Ground Floor Strategy

Consented Scheme

Revised Scheme

Revised Scheme - Block B (North Block), South Elevation

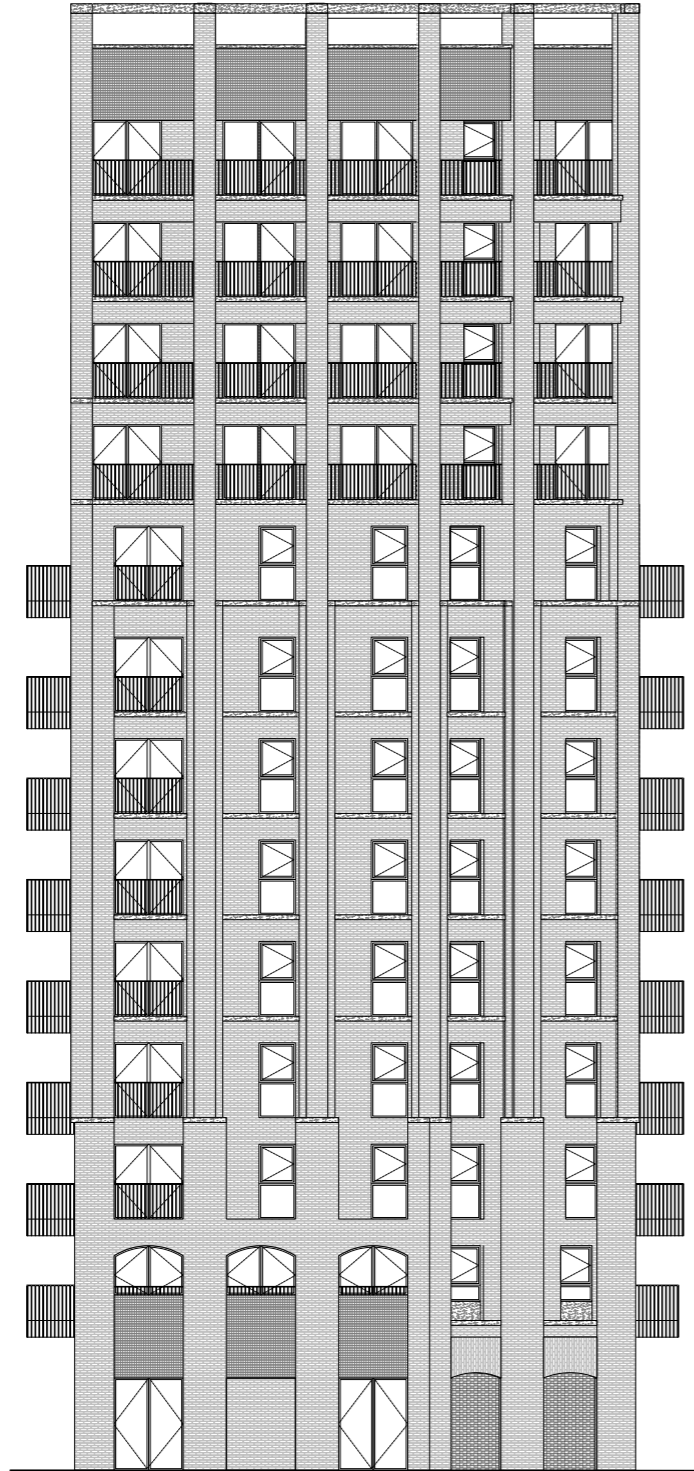
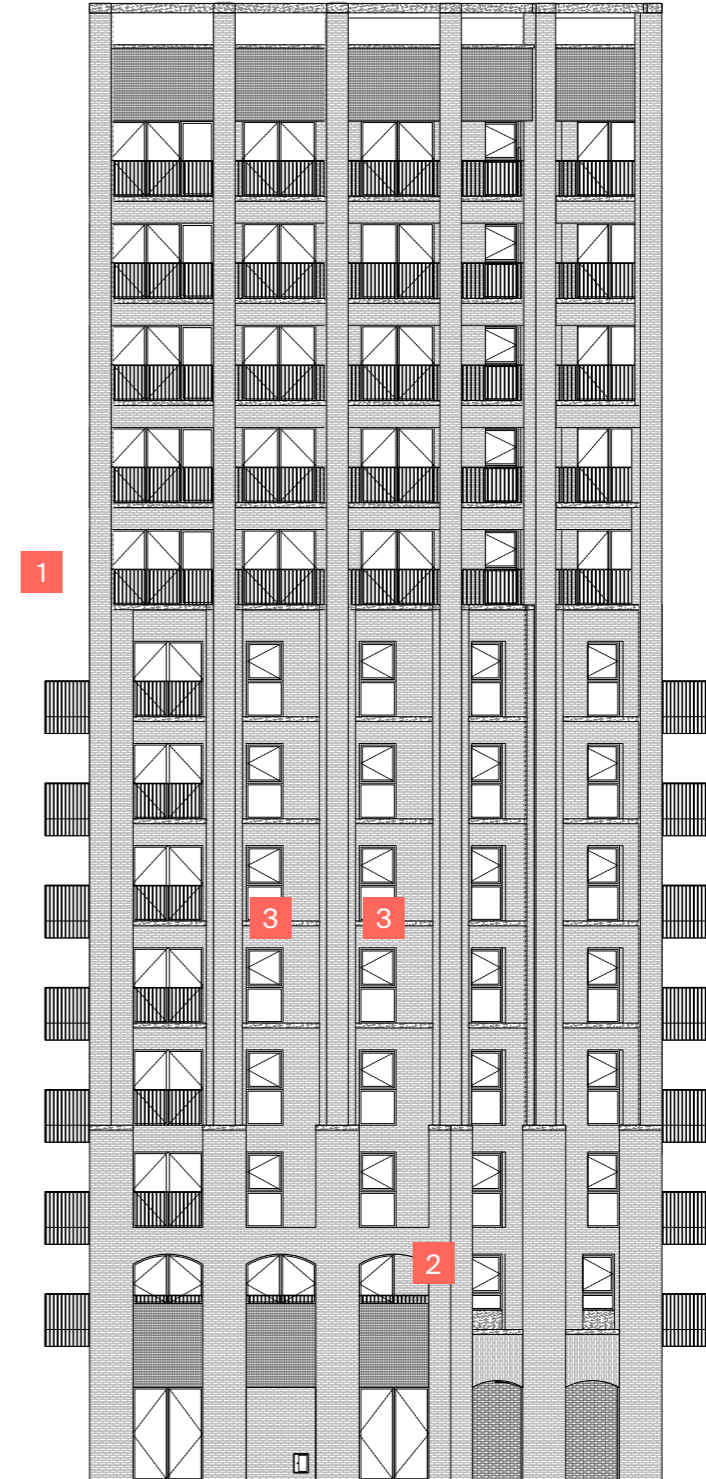
- 1** Elevation of eighth floor has been revised to match the floors above
- 2** Arched window reduced to half opening width
- 3** Adjustments made to the setting out of windows

Revised Scheme - Block B (North Block), West Elevation

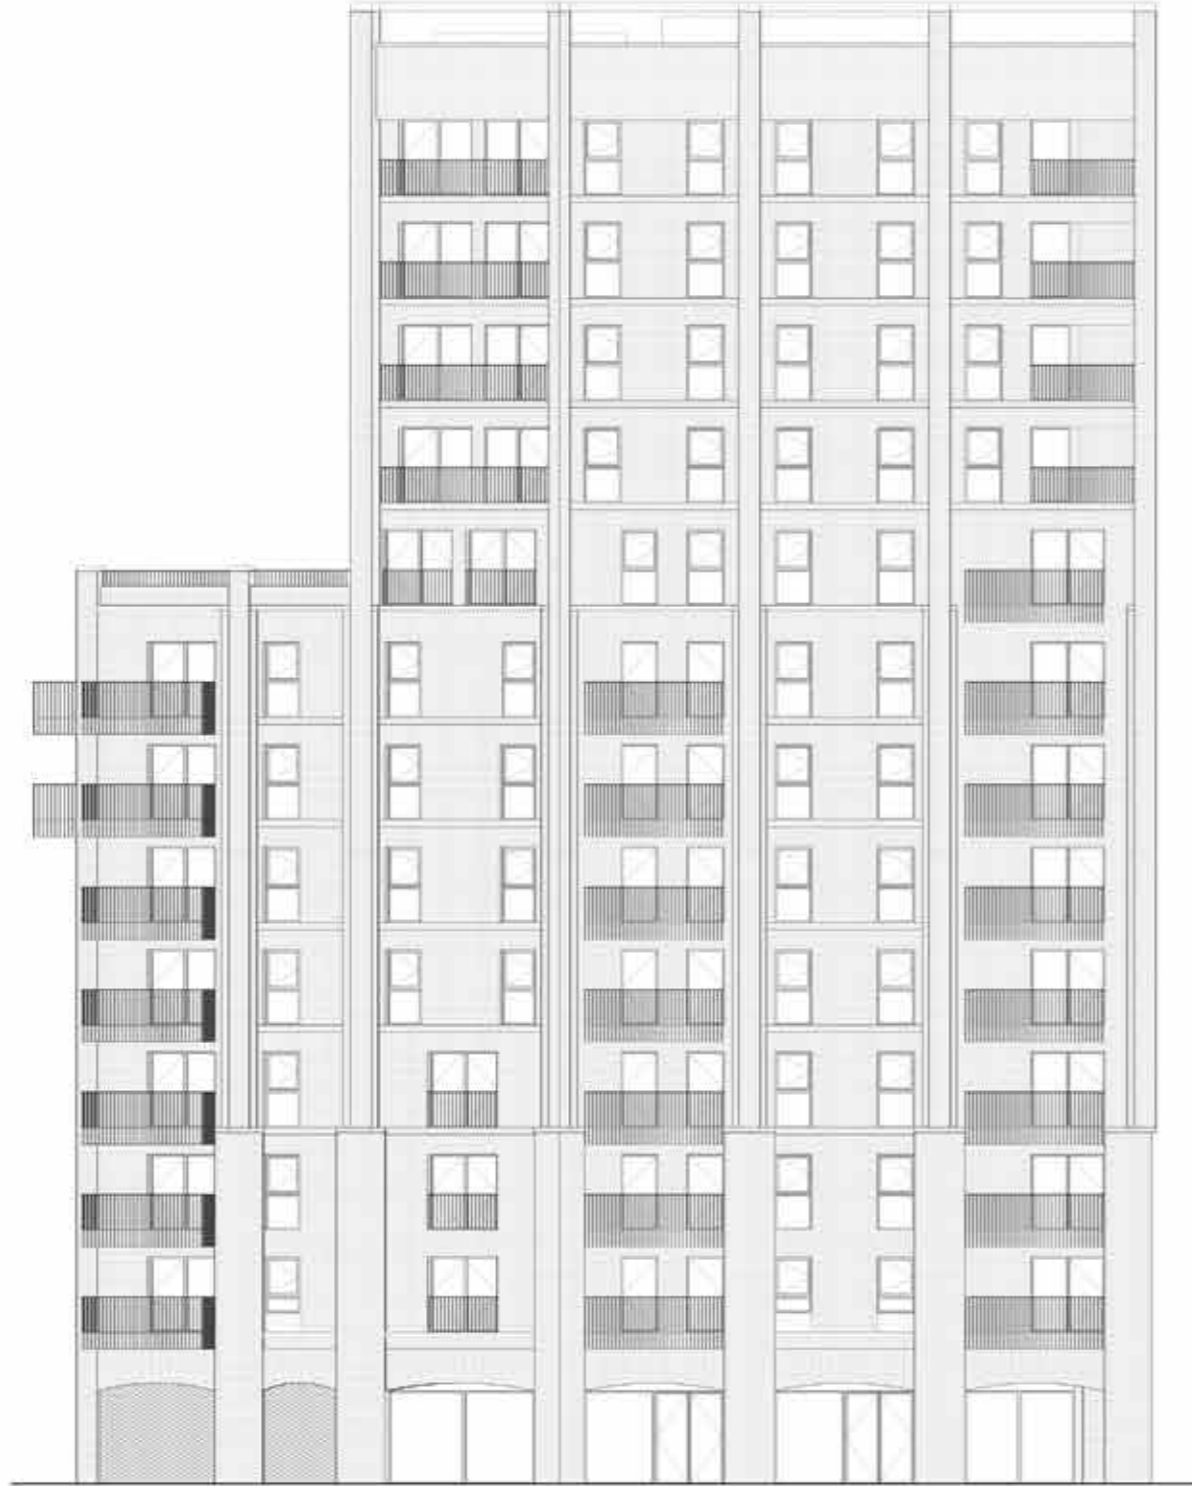
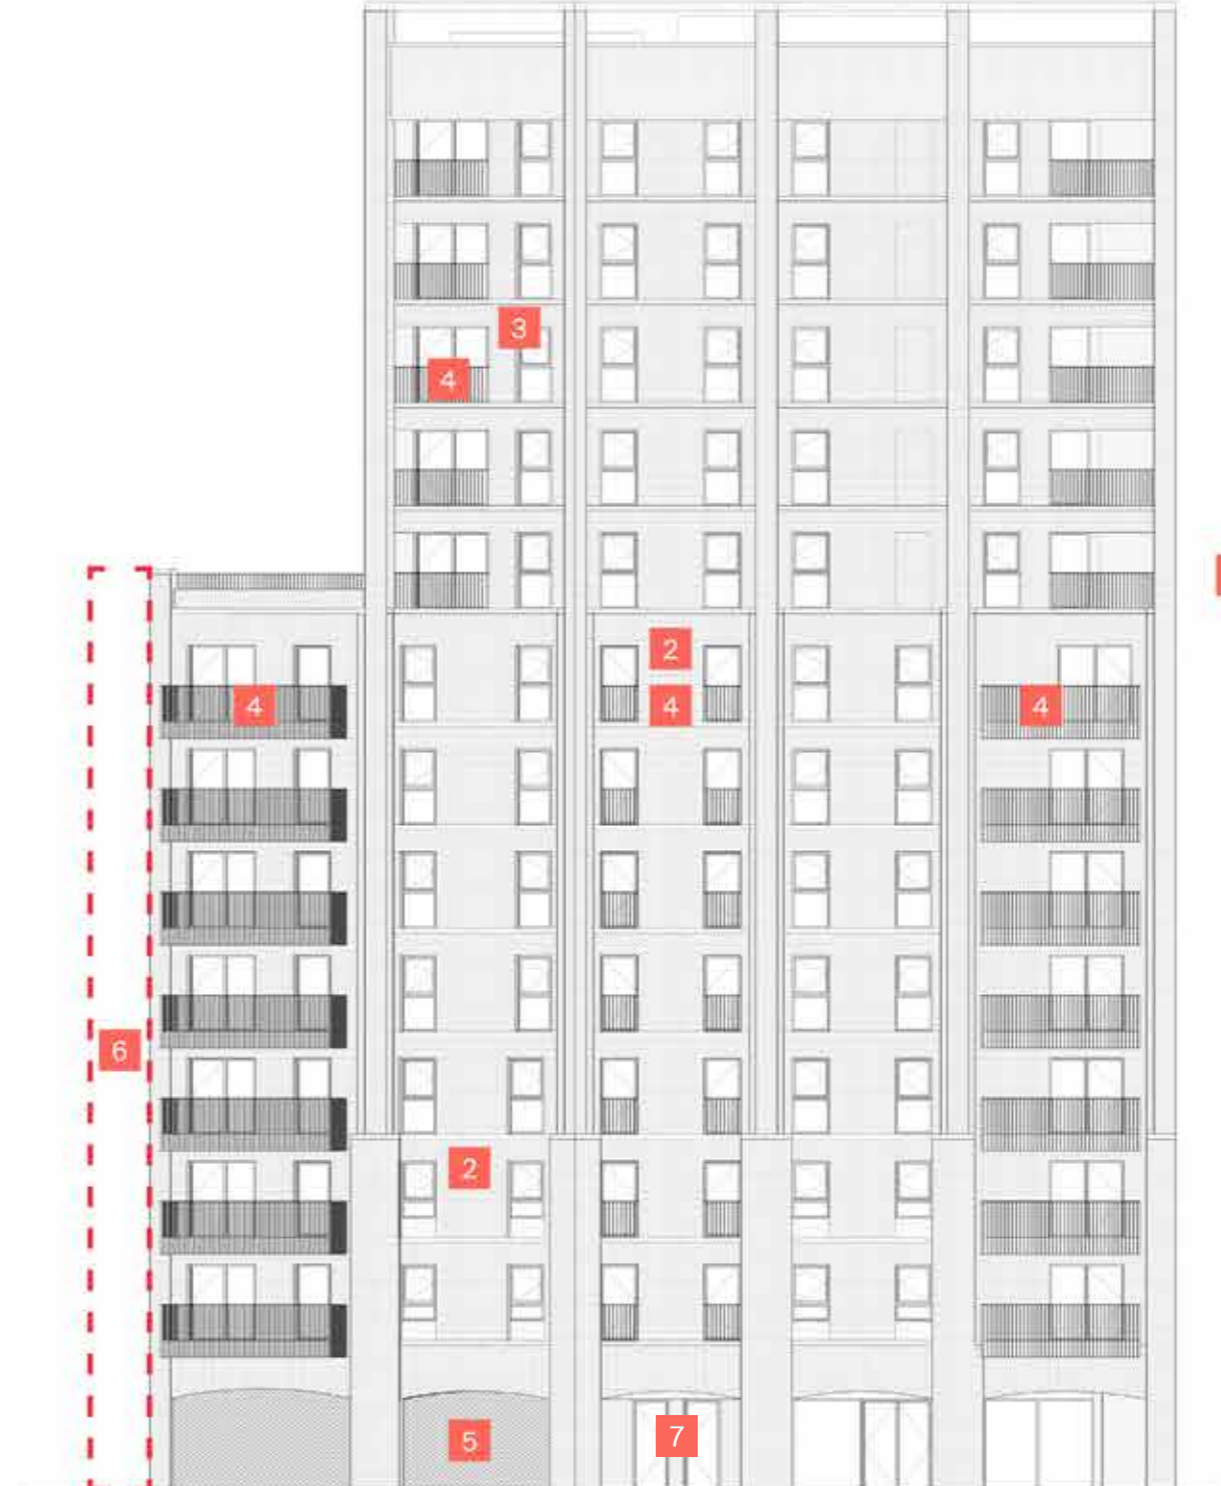
- 1** Elevation of eighth floor has been revised to match the floors above
- 2** Introduction of new windows
- 3** Adjustments made to the setting out of windows

- 5** Introduction of new perforated brickwork
- 6** Dashed red line indicates reduced massing
- 7** Minor ground floor amendments following addition of second staircas

Revised Scheme - Block B (North Block), North Elevation

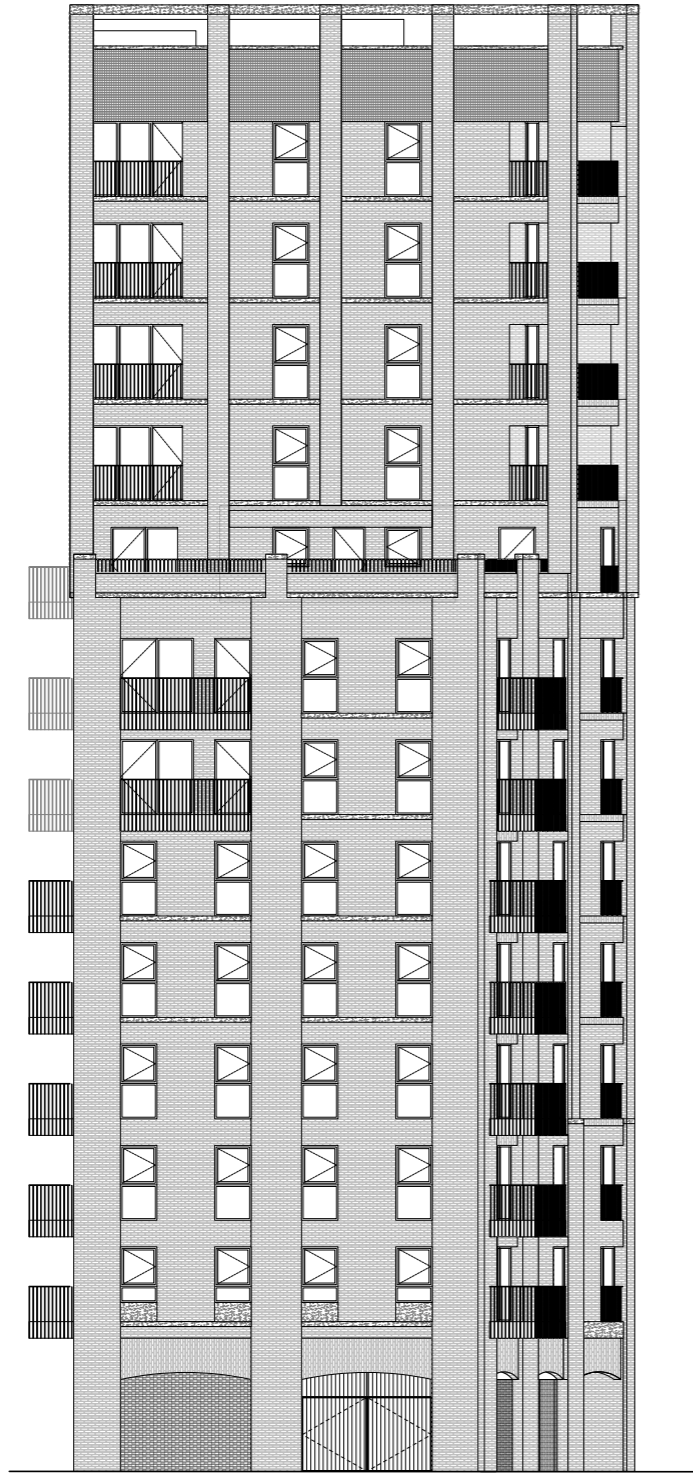
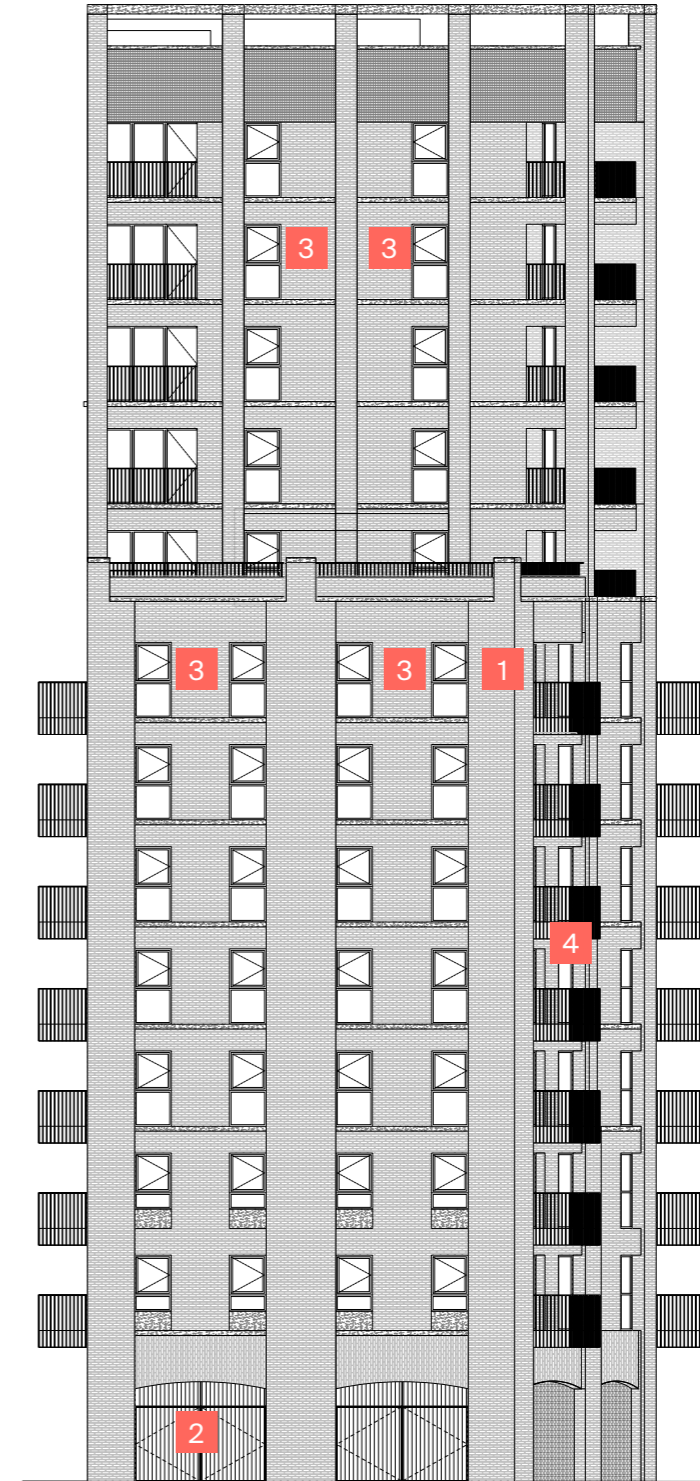
- 1 Reduced massing
- 2 Introduction of new access gates to plant room
- 3 Adjustments made to the setting out of windows
- 4 Adjustments made to the setting out and widths of balconies
